ADDENDUM NO. 3 TO PROJECT NO. 47082

CONSTRUCTION AND ELECTRICAL WORK REHABILITATE WATER FILTRATION PLANT ADIRONDACK CORRECTIONAL FACILITY 196 RAY BROOK ROAD RAY BROOK, NY

March 13, 2026

Project Sketch

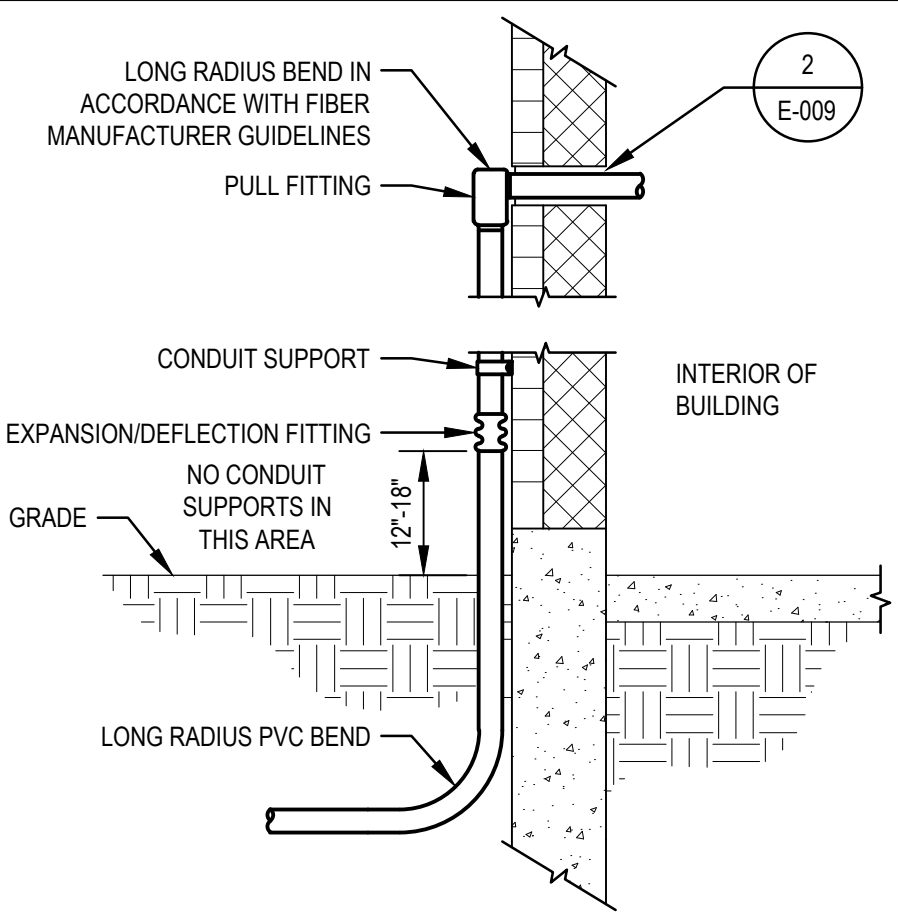
Change detail 7 Ductbank Details Sheet E-009 of project plans to provide 3' of cover at the road.

7 DUCTBANK DETAILS
SCALE: NTS

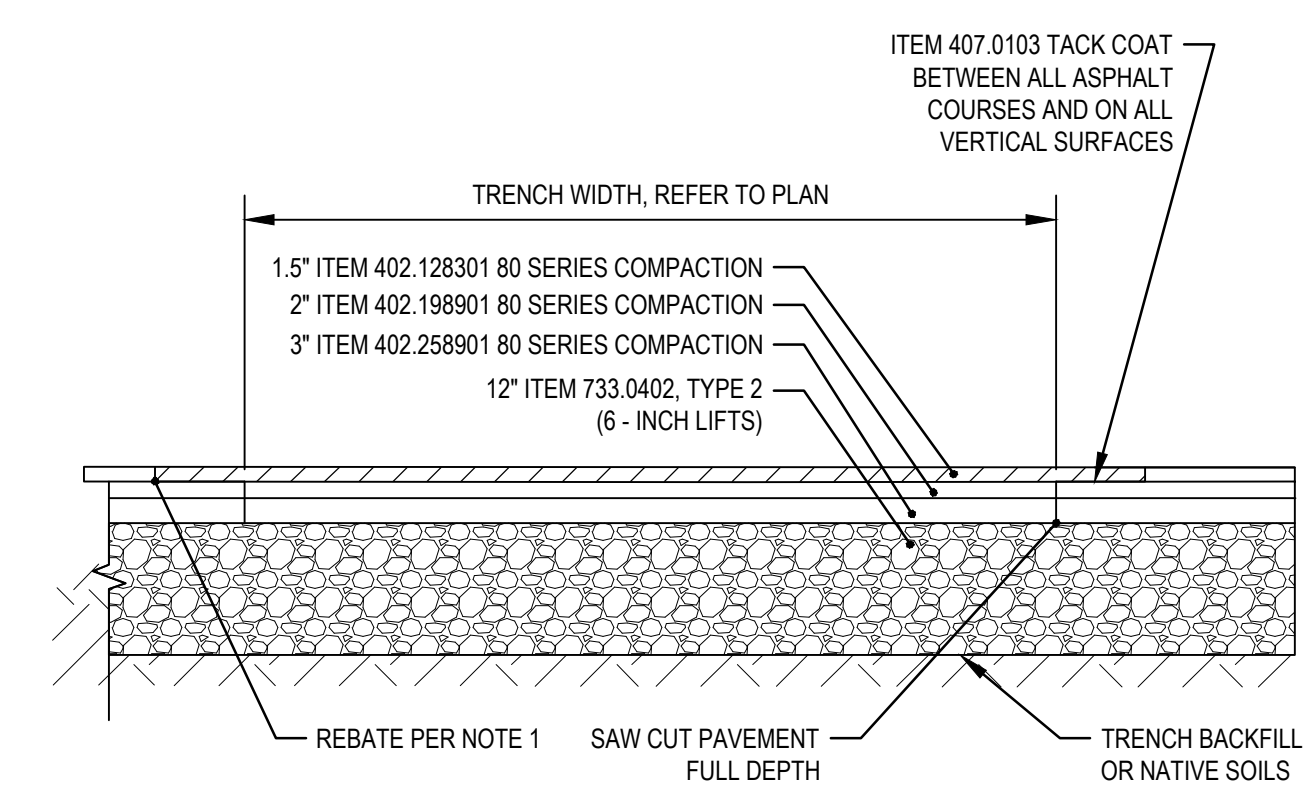
5. Revised Drawing:
 - a. Drawing No. E-009, noted Addendum 3 dated 3/13/2026, accompanies this Addendum and supersedes the same numbered previously issued drawing.

2. SECTION 310000 – EARTHWORK, Paragraph 3.21, Add the following paragraph:
 - “3.21 Trenching Under County Roads
 - a. Contractor will obtain Essex County Department of Public Works Right of Way Permit for work within the Old Ray Brook Road (County Route 35). Refer to sample permit provided in the Appendix. Trenching is required to pass under existing ditches and maintain a minimum of 36-inches of cover.”
